PD Modification Application:

PRS 22-1174

Request: Minor Modification to PD 16-0209

AGENCY REVIEW COMMENT SHEET

8.0 Site Plan
 8.2 Proposed Site Plan (Full)

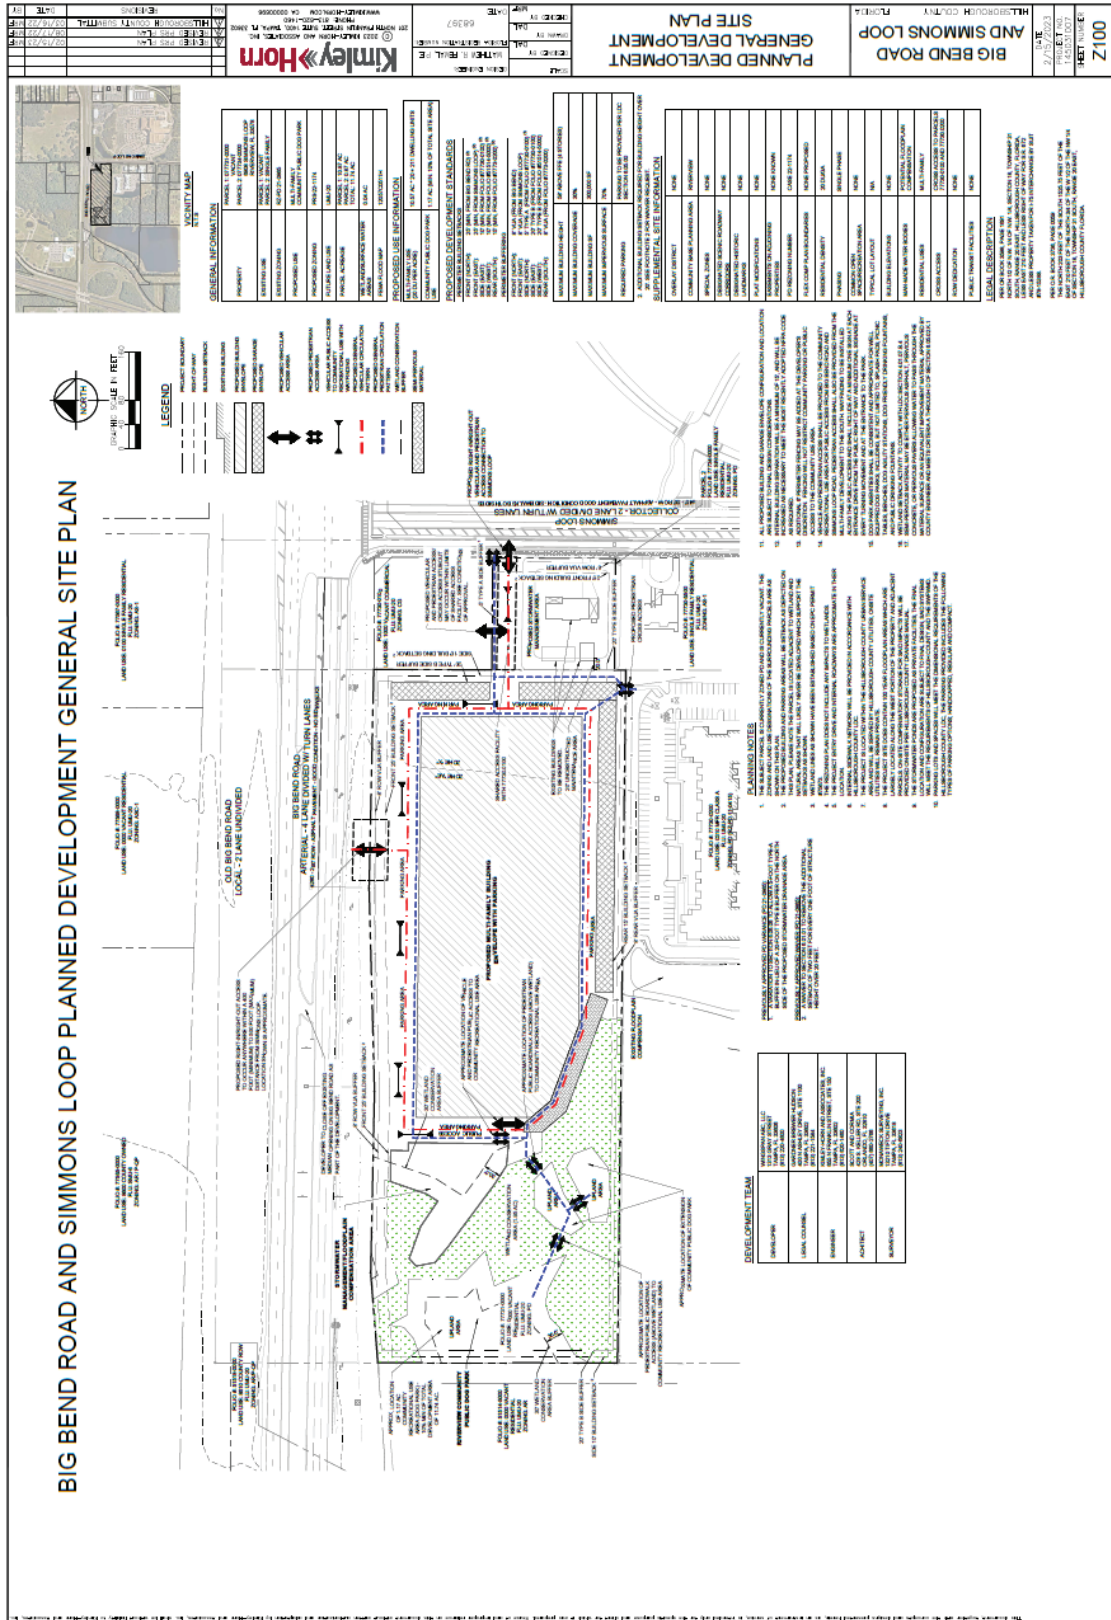
The applicant is proposing to modify approved condition 15 (proposed condition no. 17) to lower the minimum throat depth requirement from 150 feet to 60 feet. Given the nature of the proposed change, the applicant submitted a traffic analysis supporting their request; however, given that the proposed entitlements are remaining unchanged, and no access points are proposed to be added or removed, a traditional trip generation and site access analysis was not necessarily required pursuant to the Development Review Procedures Manual (DRPM).

The applicant is also proposing a modification of the site plan with respect to the confirmation/location of publicly accessible dog park, wetland boundaries, internal circulation and parking areas, and garage parking areas. Staff discussed worked with the applicant to obtain clarity and/or modify the plan to address certain CPTED issues as well as issues related to the encroachment of the drive aisle into the wetland setback area (as further discussed below).

County staff identified an issue with the reconfigured drive aisle encroaching into the newly added wetland setback areas. Pursuant to Section 6.05.02.K.1. of the LDC, drive aisles for the requested use shall “Shall be constructed with a durable and dustless surface, including but not limited to asphalt, cement, or **equivalent improvement**. No slag, rock, pea gravel or other loose type of material shall be used.” [**emphasis added**]. Transportation Review Section staff understands that Natural Resources staff determined that an encroachment into the setback could be supported if certain pervious materials were used.

Staff finds the request Approvable, subject to the following conditions listed below, and based on the general site plan submitted February 17, 2023.

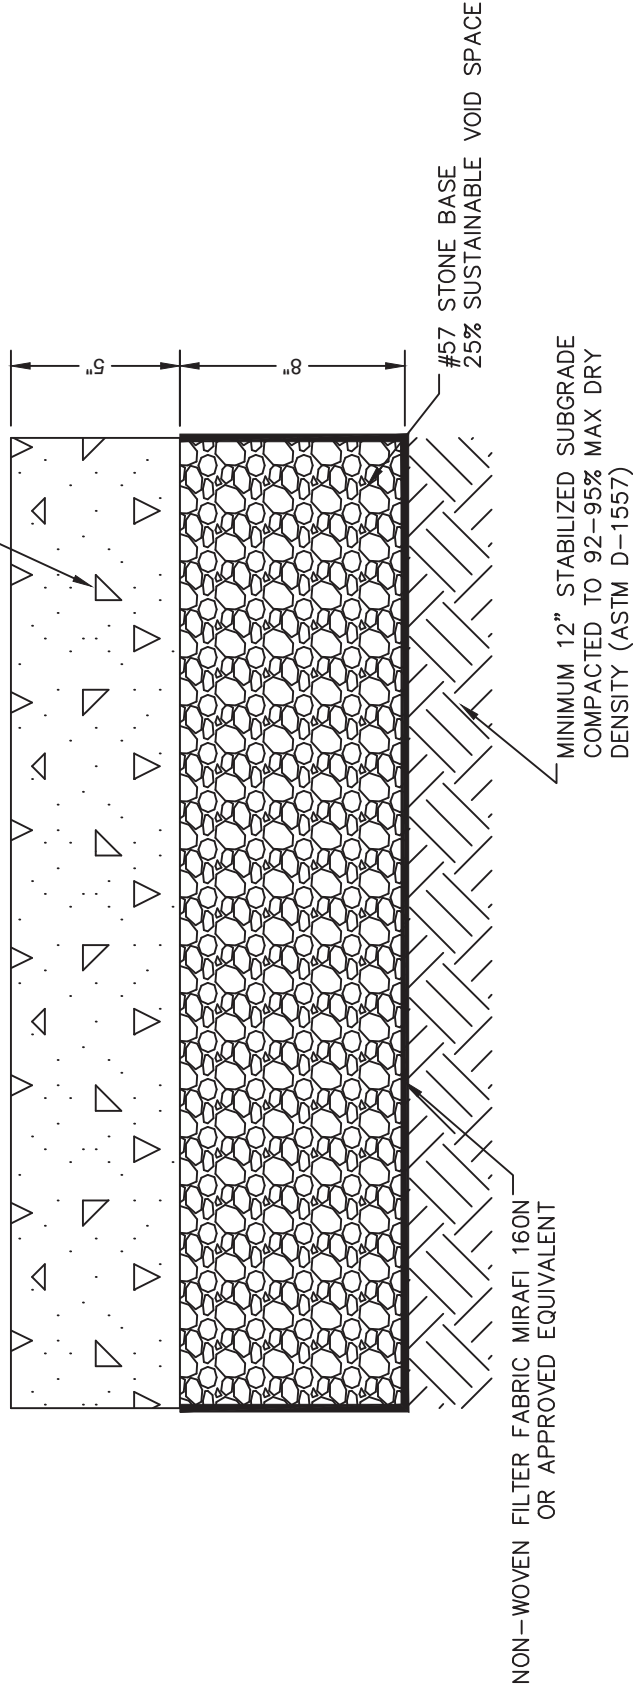
- **Type of Material Proposed:** Pervious Concrete (See Attached Detail) or approved equivalent.
- **Proposed Use:** The semi-pervious area will be approximately 5,800 SF for a proposed drive-aisle without any parking spaces.

- **Documentation:** The attached draft rezoning site plan contains a hatched area indicating the proposed limits of the semi-pervious material for the proposed drive-aisle.

Addie – the alternative pavement section in the attached will be considered approved for use should the proposed zoning modifications be approved by the Board of County Commissioners.

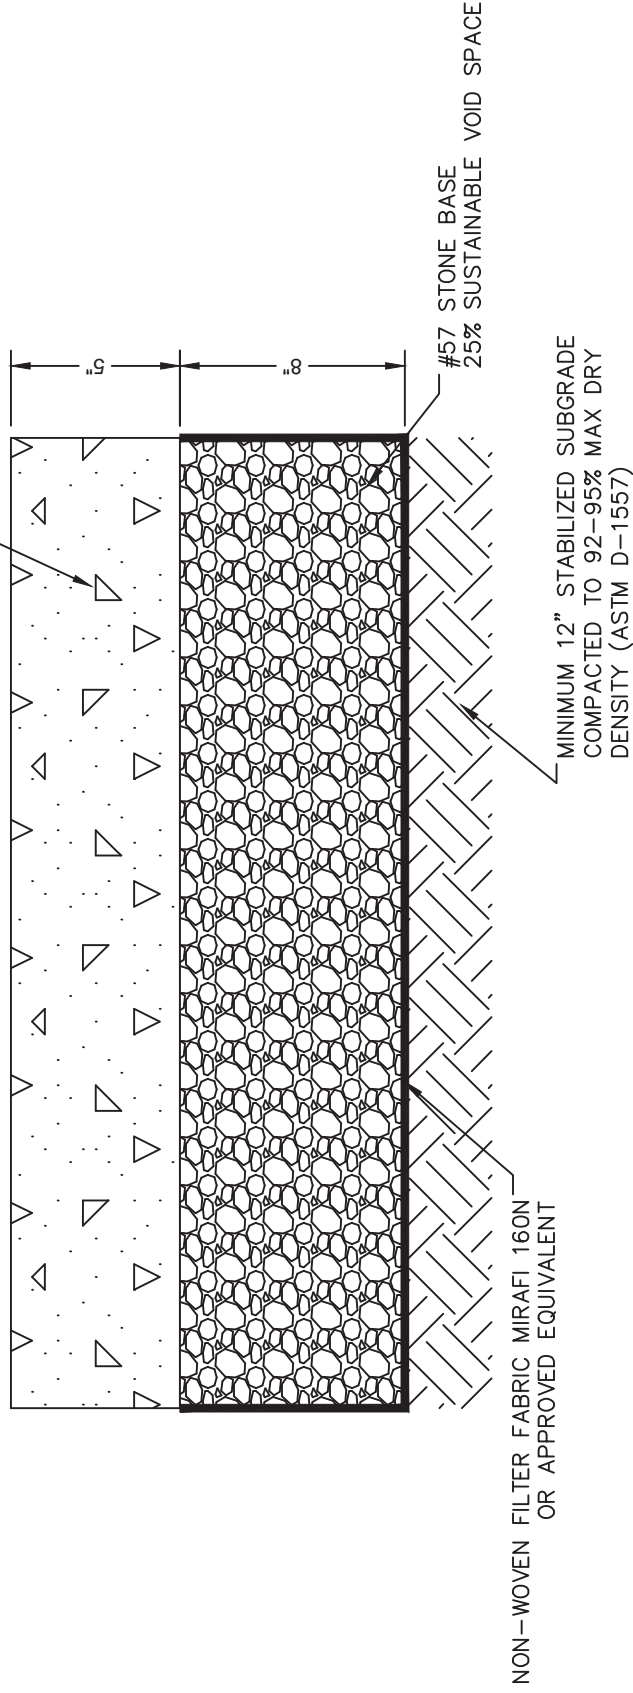
- **Type of Material Proposed:** Pervious Concrete (See Attached Detail) or approved equivalent.
- **Proposed Use:** The semi-pervious area will be approximately 5,800 SF for a proposed drive-aisle without any parking spaces.

- **Documentation:** The attached draft rezoning site plan contains a hatched area indicating the proposed limits of the semi-pervious material for the proposed drive-aisle.

Addie – the alternative pavement section in the attached will be considered approved for use should the proposed zoning modifications be approved by the Board of County Commissioners.

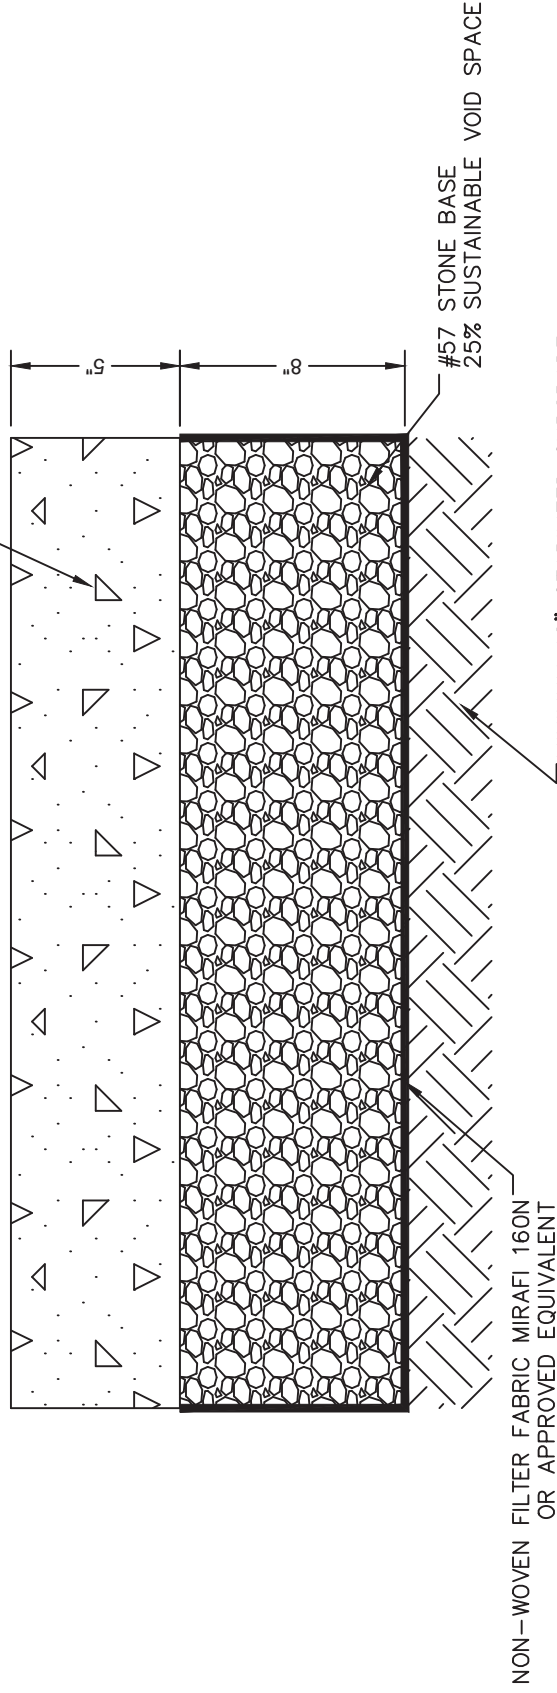
- **Type of Material Proposed:** Pervious Concrete (See Attached Detail) or approved equivalent.
- **Proposed Use:** The semi-pervious area will be approximately 5,800 SF for a proposed drive-aisle without any parking spaces.

- **Documentation:** The attached draft rezoning site plan contains a hatched area indicating the proposed limits of the semi-pervious material for the proposed drive-aisle.

Addie – the alternative pavement section in the attached will be considered approved for use should the proposed zoning modifications be approved by the Board of County Commissioners.
